ADDENDUM NO. 1

DATE: **March 30, 2026**
OWNER: **Town of Tignall**
PROJECT: **Wastewater Treatment Plant Improvements**
C & S PROJECT NO.: **T7040.003**

**WWTP IMPROVEMENTS
FOR THE
TOWN OF TIGNALL
WILKES COUNTY, GEORGIA**

EXISTING SITE PLAN - SOUTH

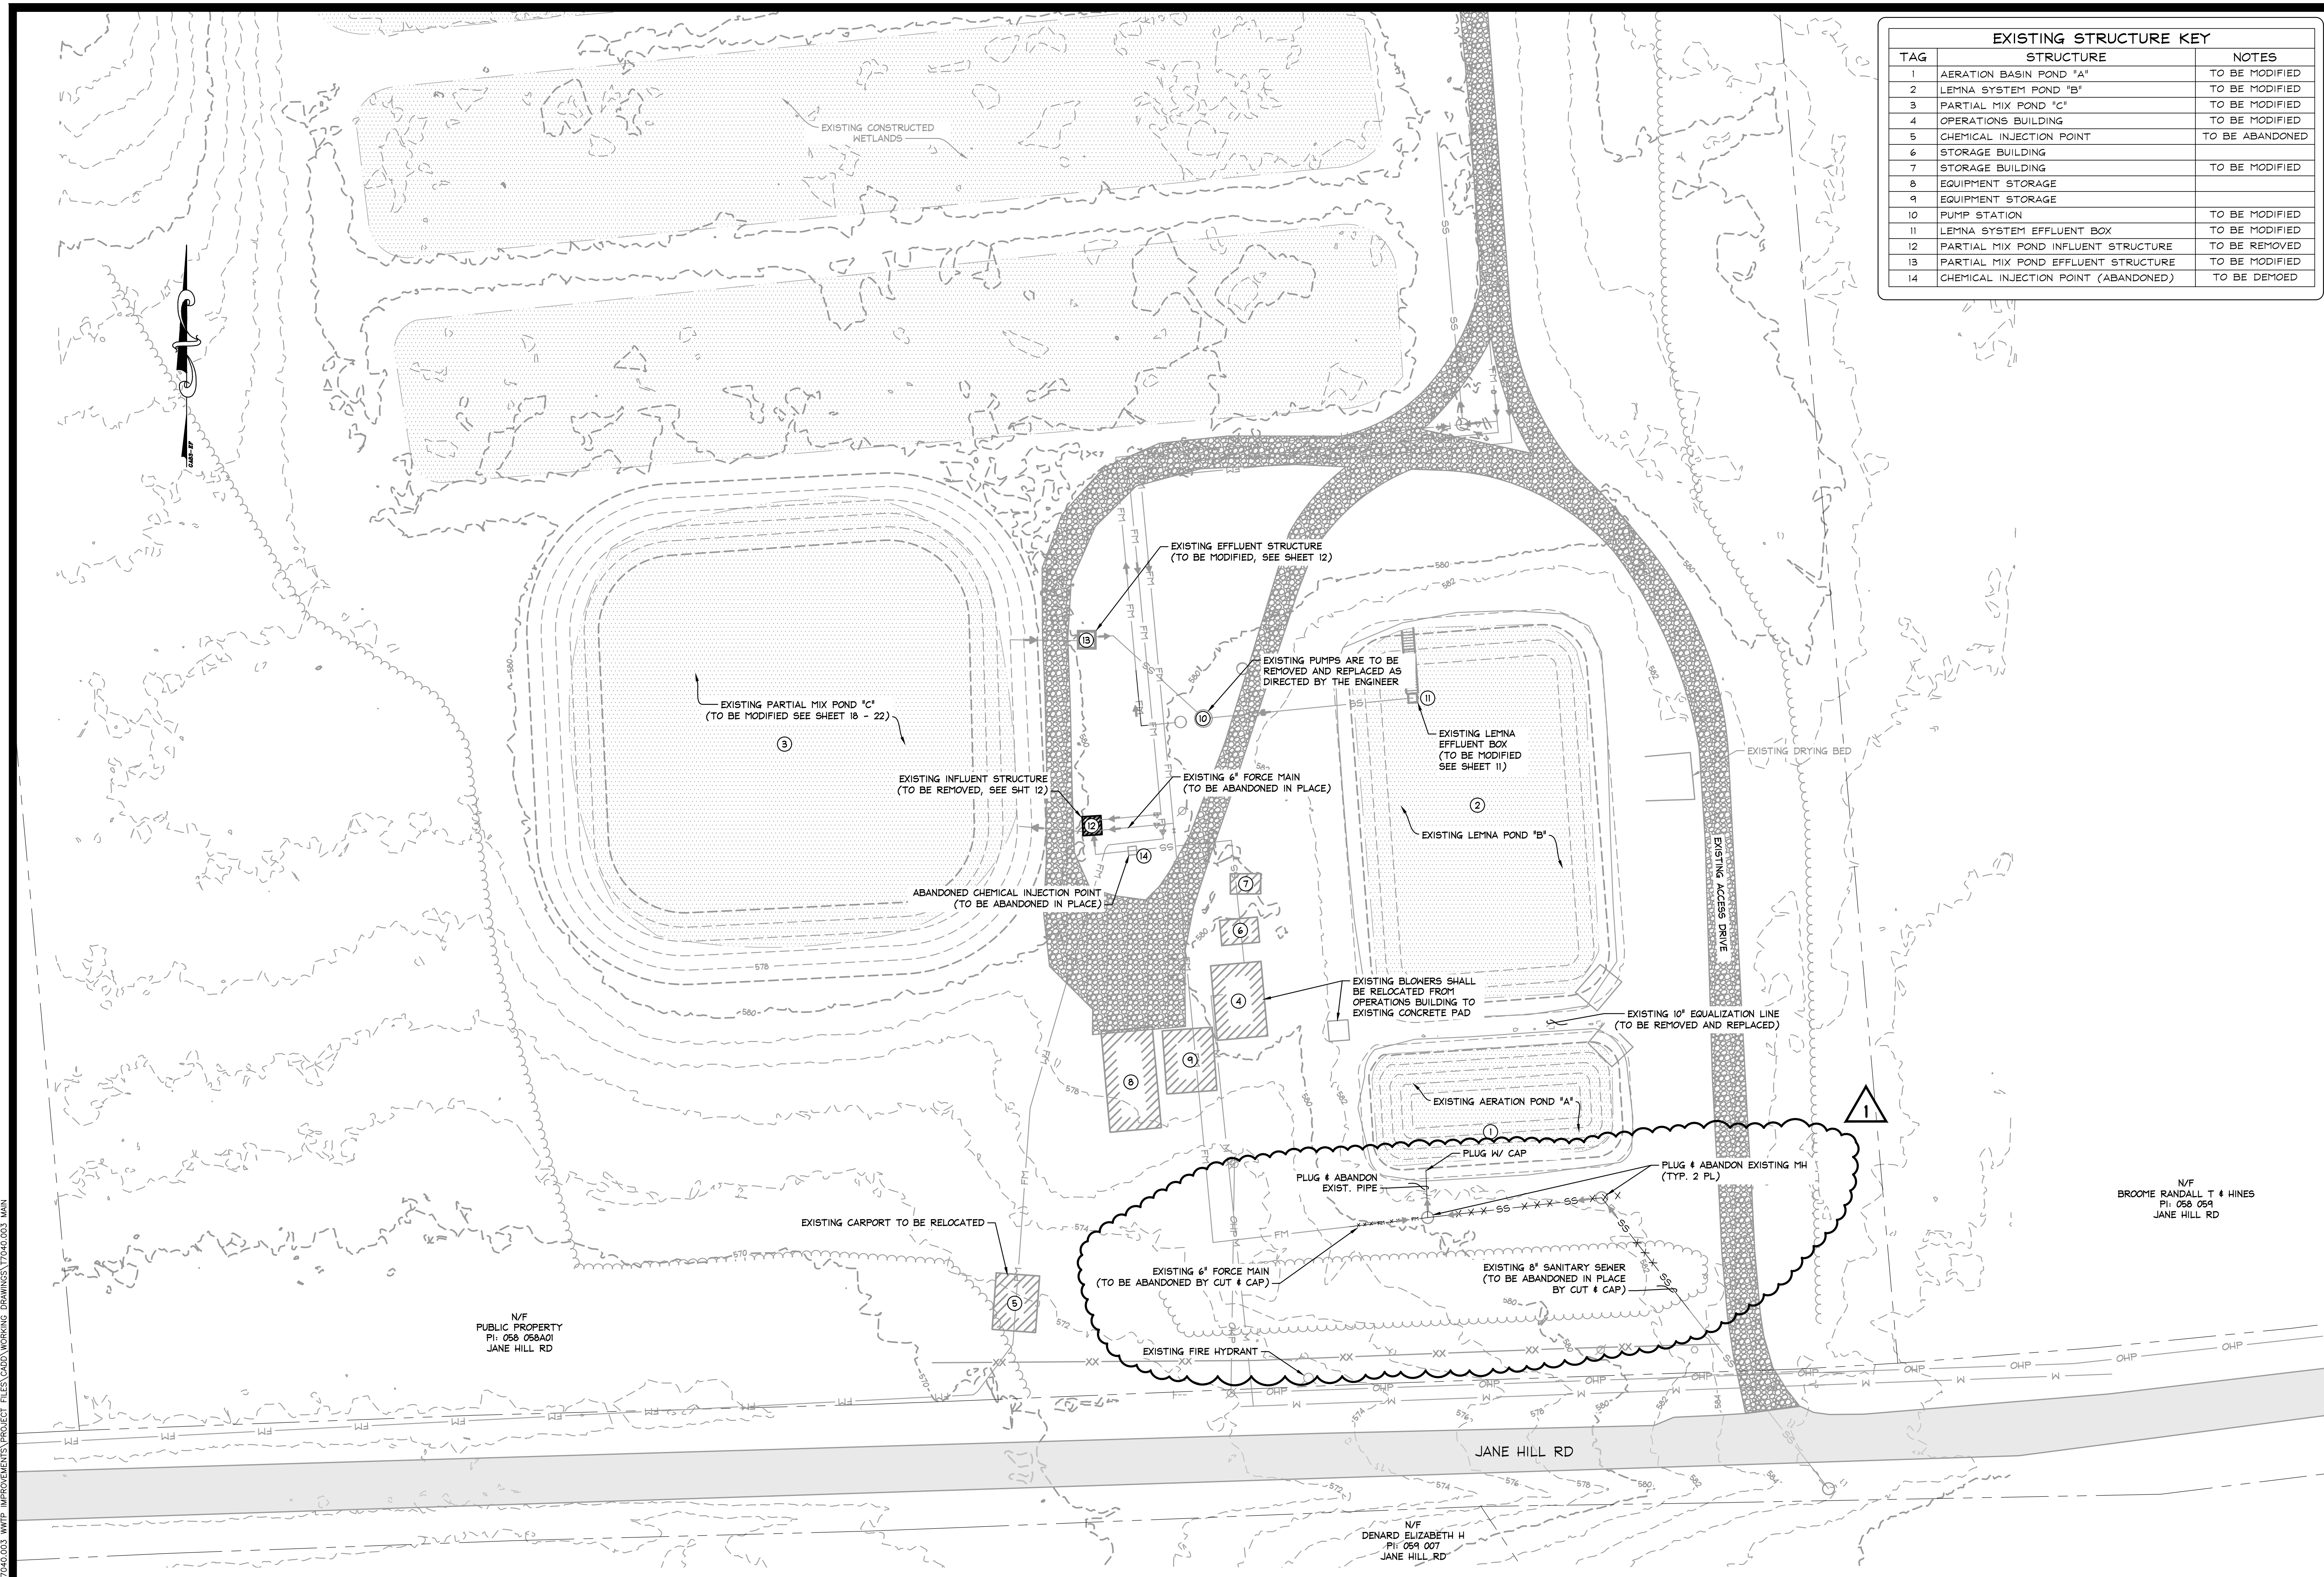
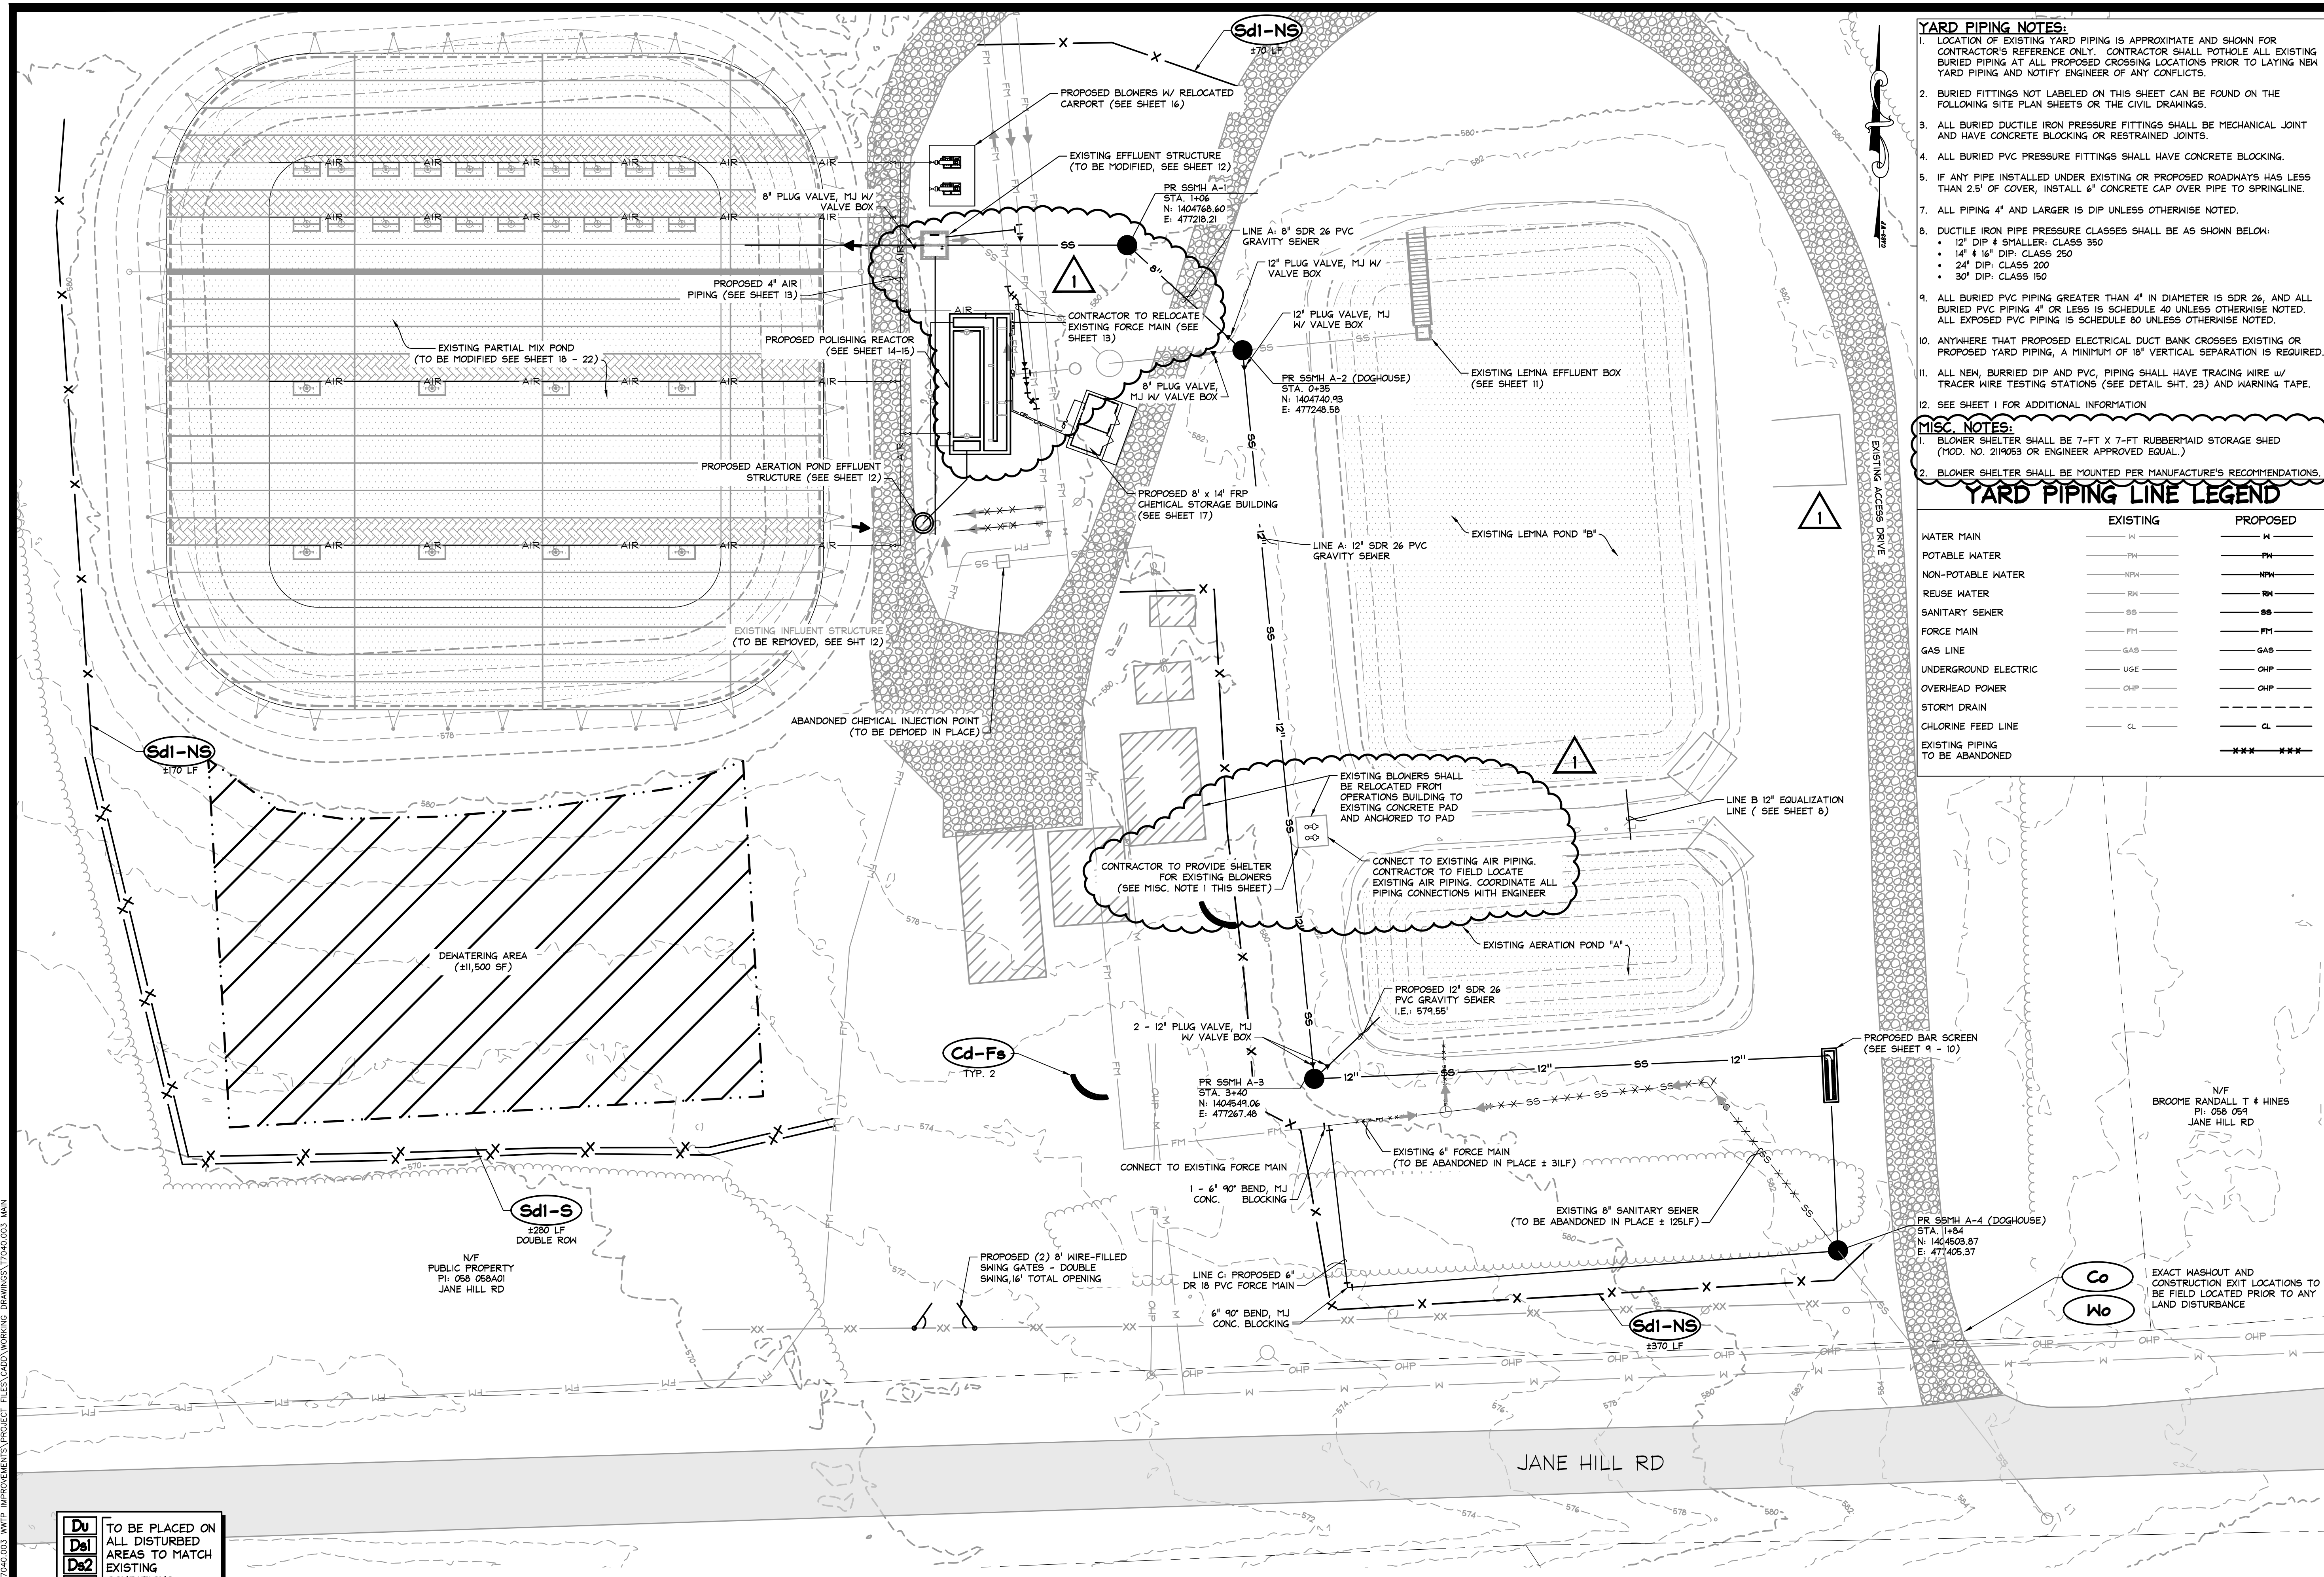
5. **Question:** Is there any other water source besides the $\frac{3}{4}$ residential?
Answer: There is a fire hydrant located on Jane Hill Rd. just outside the WWTP fence. The Contractor may use that fire hydrant for water, but they must furnish and install a hydrant meter. The Town does not have a hydrant meter. The location of the hydrant is shown on revised Sheet 5 included in this addendum.
